Informal document **GRRF-76-45** (76th GRRF, 16 – 20 February 2014, agenda item 5(a))

# Proposal for amendments to Regulation No. 78

# (Uniform provisions concerning the approval of vehicles of categories $L_1, L_2, L_3, L_4$ and $L_5$ with regard to braking)

# Submitted by the expert from the International Motorcycles Manufacturers Association

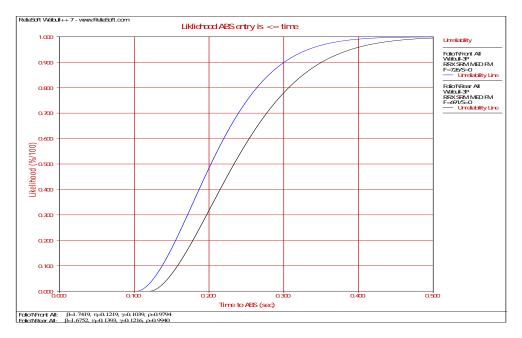
It has been noticed in testing that the brake application rate specified in section 4.9.5.1 can result in a large number of test failures. If can be seen in the chart below that the 0.2 second lower limit shows a failure rate is between 30 per cent and 50 per cent of the time.

By reducing the lower limit to 0.1 seconds, the test failure rate reduces to practically zero. Allowing the reduction tends to make the regulation more stringent by including a greater number of brake force application rates and eliminates restrictive test requirements.

The brake control actuation force is applied in  $0.2 \ 0.1 - 0.5$  seconds."
